Technical Memorandum

To:	SJBA Technical Advisory Group
From:	Wildermuth Environmental Inc. (WEI)
Date:	June 21, 2016; Updated August 30, 2016
Subject:	San Juan Basin 2016 Adaptive Pumping Management (APM) Plan

Attachment B: Response to Comments

Figure 7
Groundwater Elevation at SCWD MW-4S and MWD OC MW-2M Wells
and Subsurface Outflow to the Pacific Ocean
2016 Adaptive Pumping Management Alternative

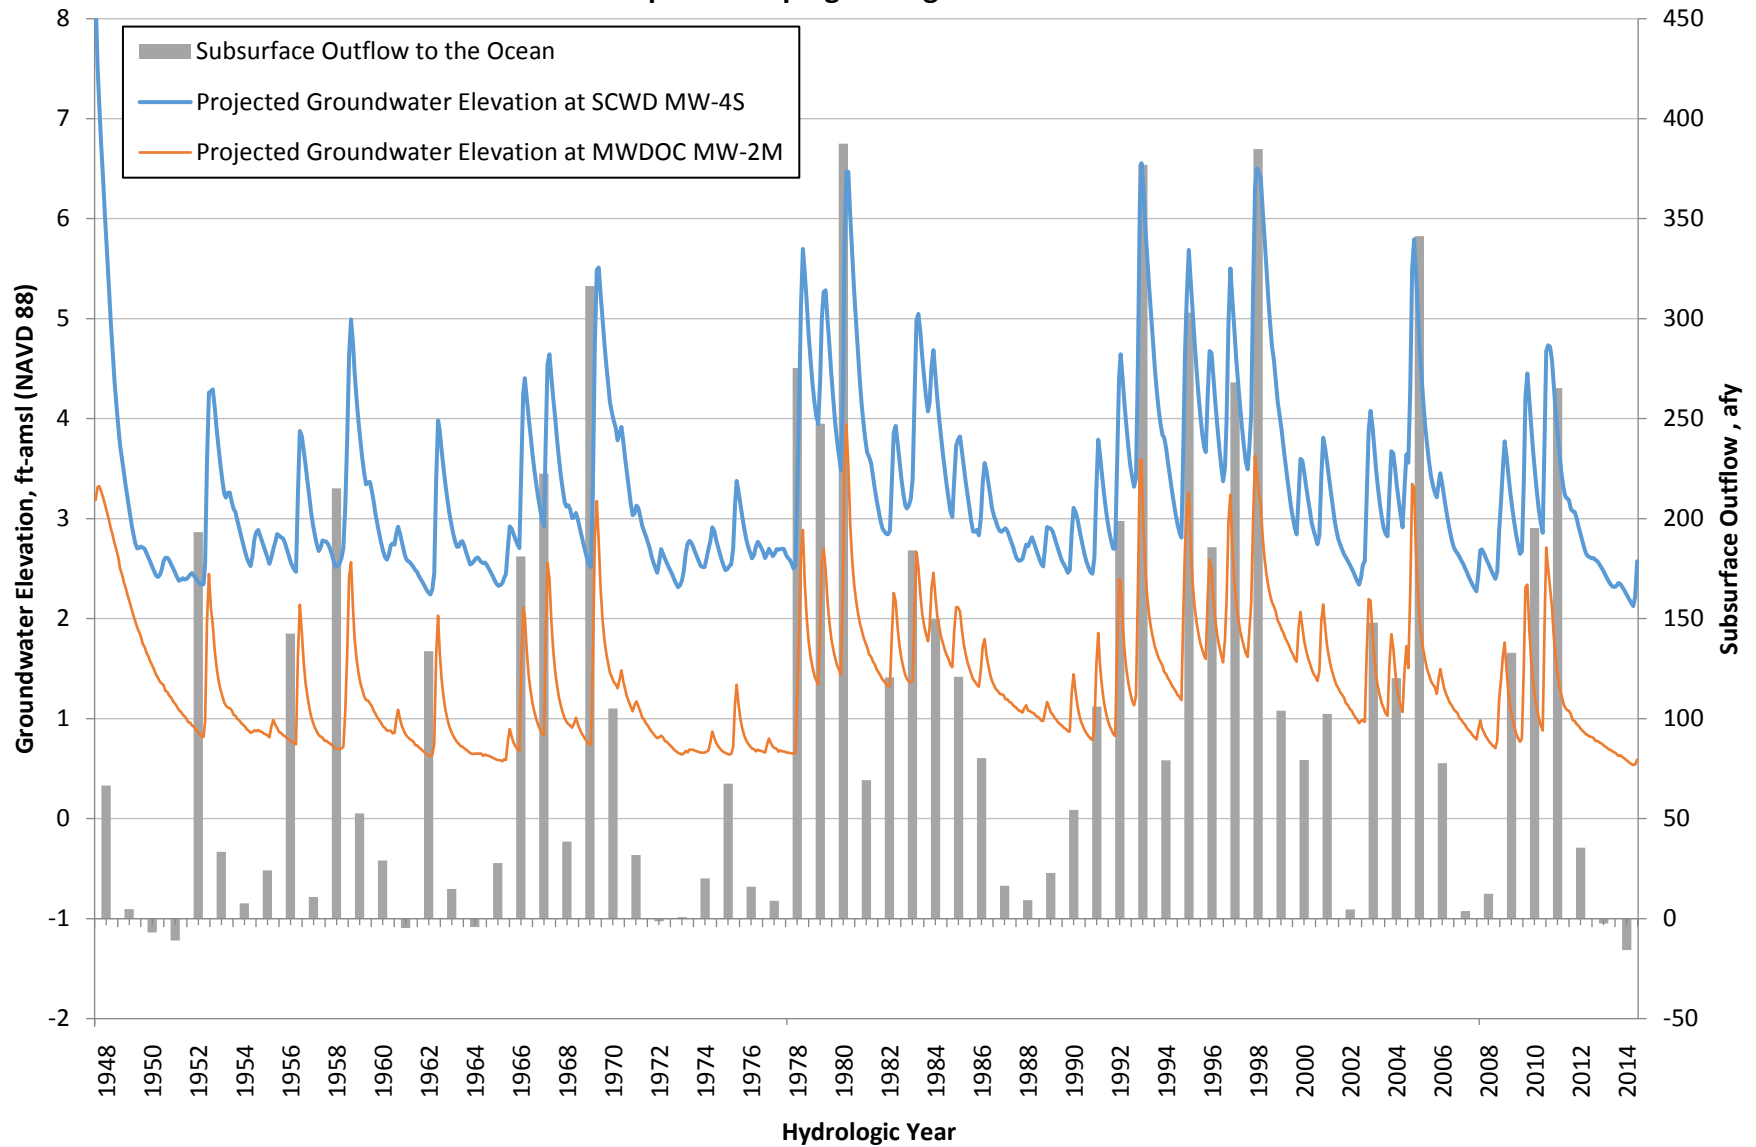
- 7. Page 8, comment – Figure 7 is referring to “projected” groundwater elevation but refers to years that are in the past. How does this work?**

WEI Response: Great question. The model was used to project the hydrologic response of the basin assuming current land use and water supply plans (cultural conditions) and a repeat of the hydrologic period of 1947 to 2014. Because we can't reliably predict future precipitation for any given year, the historical precipitation record was used. So, to interpret Figure 7, you would look to hydrologic year 1978 to see what the expected groundwater level and subsurface outflow conditions would be for 1978 (a very wet year) and the hydrologic conditions and management activities leading up to and during that year.

Figure 13
2016 Adaptive Pumping Management
Sustainable Pumping Curve Based on Modeled Spring Storage-Pumping Relationship

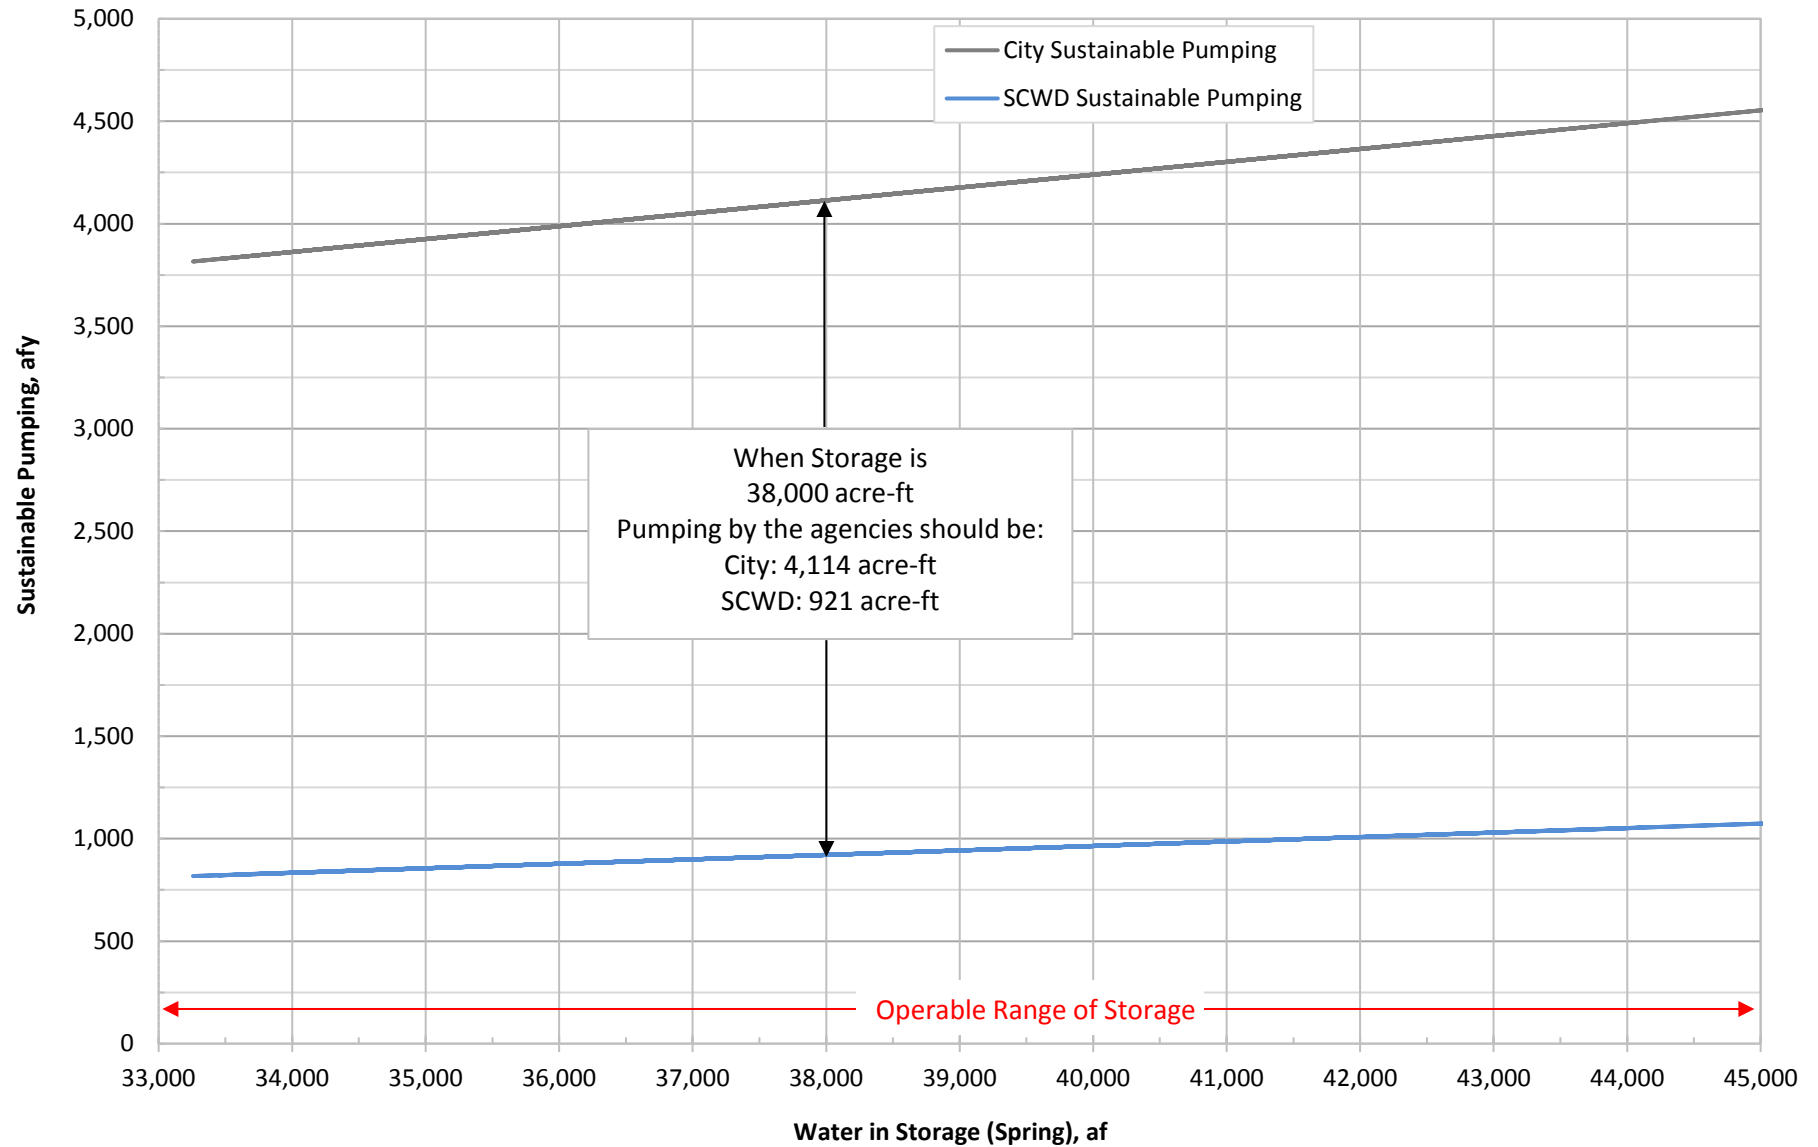
- 1. Figure 13 appears a little off. Specifically, the allocation formula used for the ratio of SCWD and SJBA (used by CSJC per Agreement) needs to be adjusted to 20%/80% respectively. The ratio should be consistent with the Agreement between the SJBA and Capistrano Beach Water District (now SCWD) of March 1, 1998, which identifies Allocations of Water based on Available Safe Yield of: 20% to Capistrano Beach Water District (now SCWD) and 80% to the Authority (SJBA – again, of which SJBA has an Agreement with CSJC).**

- 10. Figure 13 – Does not reflect the current agreement of 80% SJBA/20% SCWD.**

WEI Response: You are correct that Figure 13 does not allocate pumping to the City (SJBA) and SCWD per the 80/20 formula in the referenced agreement. The formula used to create Figure 13 is based on the relationship of storage and sustainable pumping in the 2016 APM alternative, which allocates pumping at wells in order to comply with the permit conditions. The model limits pumping by both agencies when pumping limits are required. Specifically, the run was designed to reduce pumping in a proportionate manner, but did not achieve an exact 80/20 split. In applying the pumping limitations, the allocation of the sustainable pumping pursuant to water rights permits to the City and the SCWD ends up at about 82% and 18%, respectively. Over the entire simulation period the difference between the SCWD's 20 percent allocation and the model allocation ranges from 52 to 110 afy, and averages 88 afy.

WEI Response: Please refer to WEI's response to Comment 1.
